February 27, 2004

Brake System Wiring

MODELS AFFECTED: All Blue Bird Visions

S04HJ

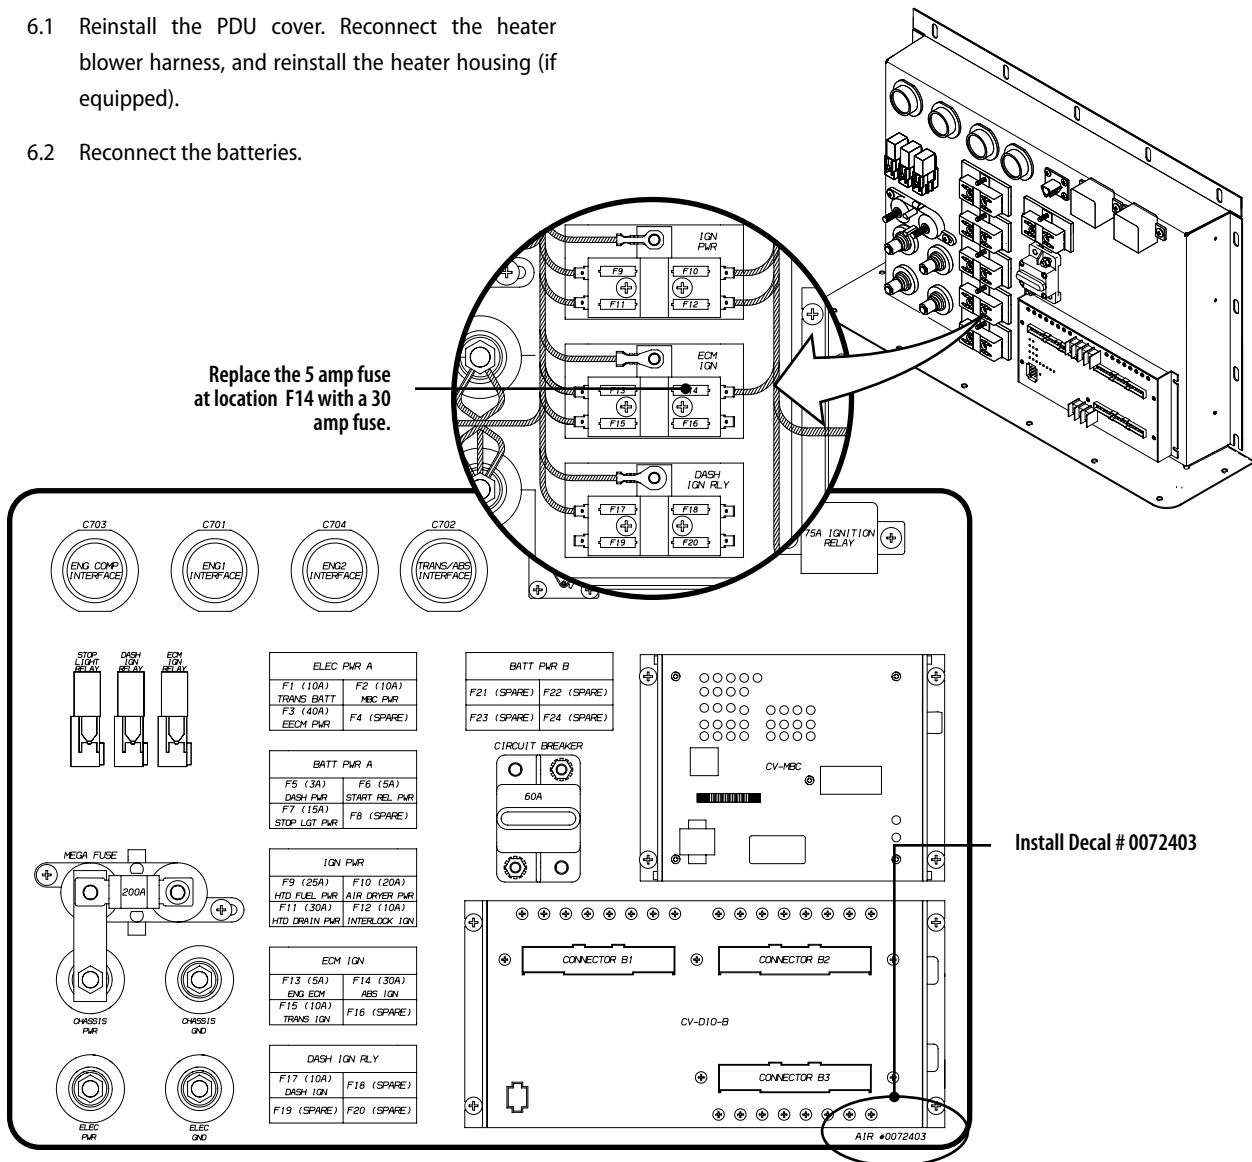
- 5.1 Locate the ECM IGN fuse block. In location F14 ABS IGN, replace the 5 amp fuse with a 30 amp fuse.
- 5.2 Install the new decal labeled Air #0072403 on top of the existing decal on the inside of the PDU cover.

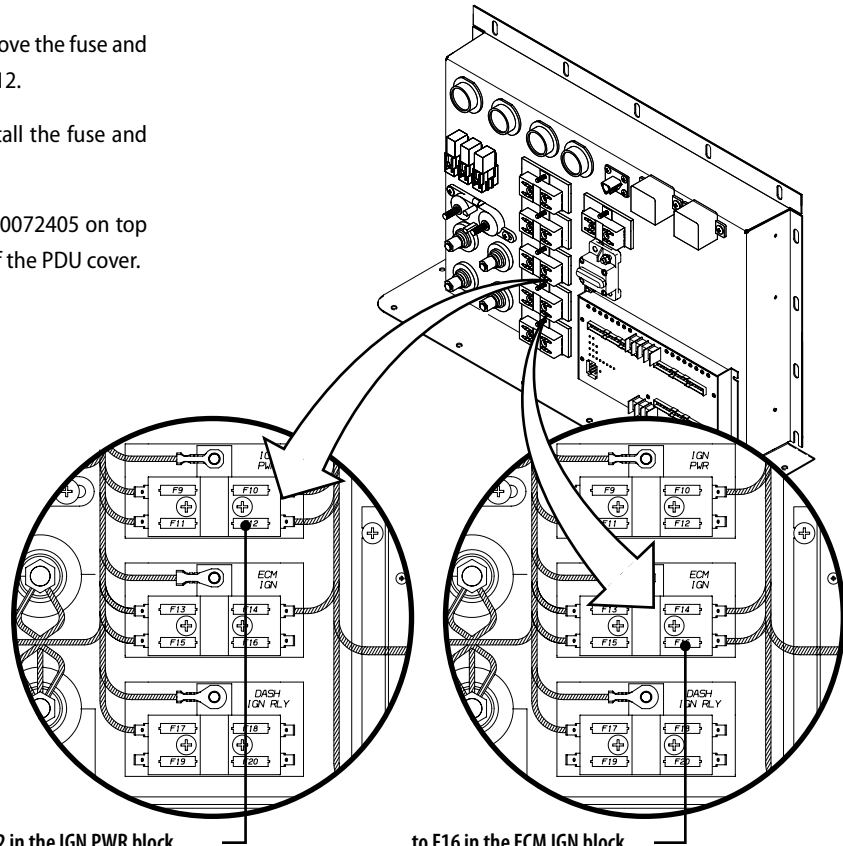
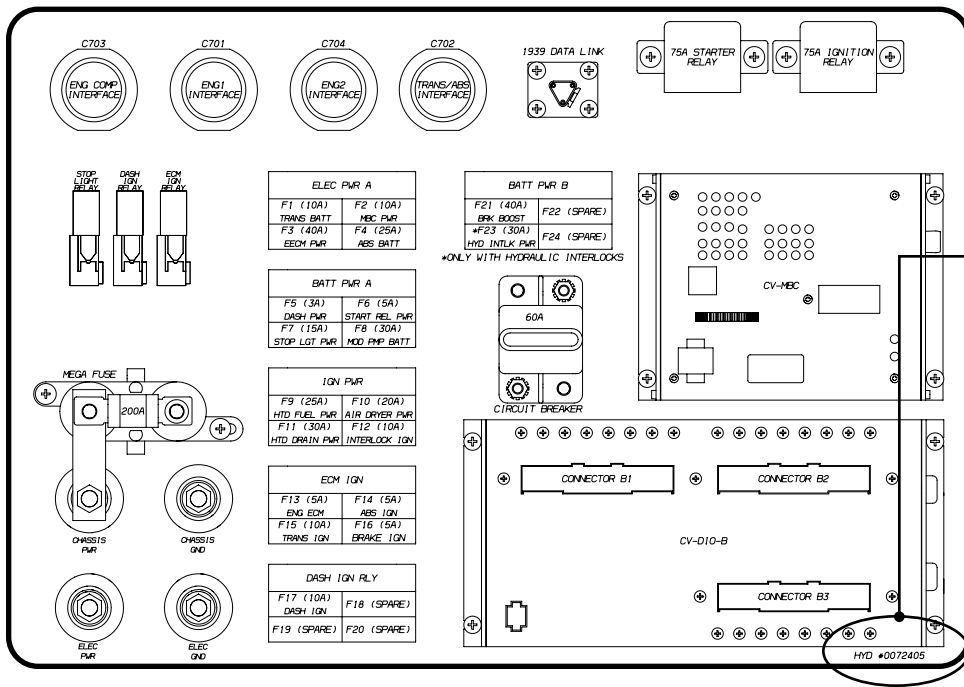
- 7.1 Locate the IGN PWR fuse block. Remove the fuse and disconnect the wire from location F12.
- 7.2 Locate the ECM IGN fuse block. Install the fuse and connect the wire at location F16.
- 7.3 Install the new decal labeled HYD #0072405 on top of the existing decal on the inside of the PDU cover.

Move the fuse and wire from F12 in the IGN PWR block...

...to F16 in the ECM IGN block.

Install Decal # 0072405.

Diode spliced in place

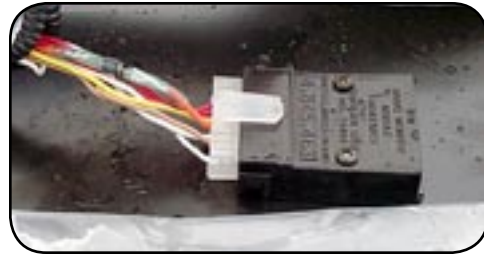
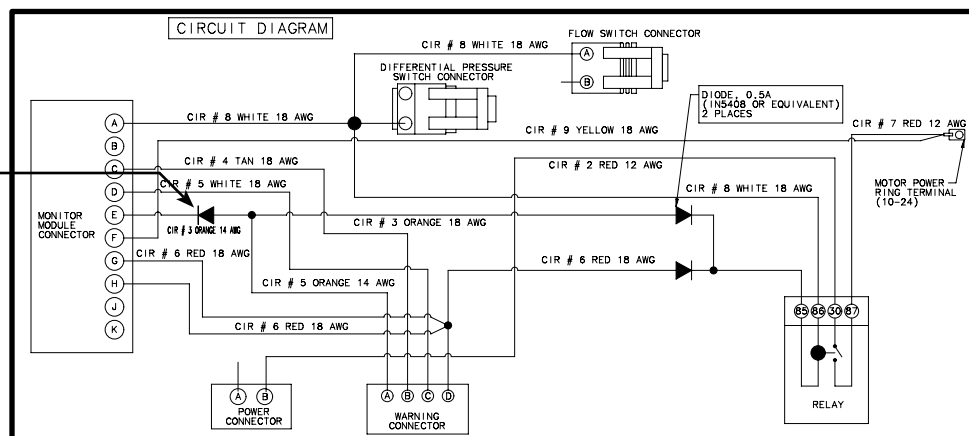
- 8.5 Cut the orange wire approximately 1" from the connector. Trim 1/4" of insulation from both cut ends.

- 8.6 Splice the diode assembly between the cut ends of the orange wire. Be sure to orient the diode with its colored band toward the harness connector block.

- 8.7 Apply heat to the butt connectors to shrink the insulators around the wires and diode. Reinstall the split wire loom and tape the end of the loom with electrical tape.

Install Diode 1320977.

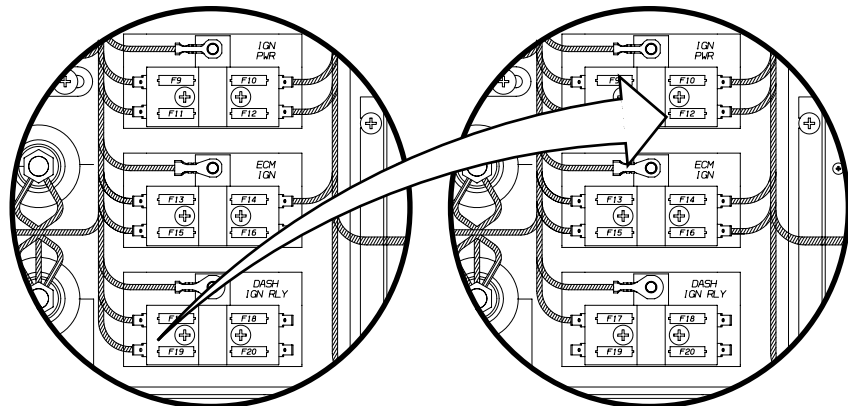
- 10.1 Locate the DASH IGN RLY fuse block. Remove the fuse and disconnect the wire from location F19.
- 10.2 Locate the IGN PWR fuse block. Install the fuse and connect the wire at location F12.
- 10.3 Install the new decal labeled HYD #0072405 on top of the existing decal on the inside of the PDU cover.
- 10.4 Reinstall the PDU cover. Reconnect the heater blower harness, and reinstall the heater housing (if equipped).
- 10.5 Reconnect the batteries.

Move the fuse and wire at location F19 in the DASH IGN RLY block...

...to location F12 in the IGN PWR block.
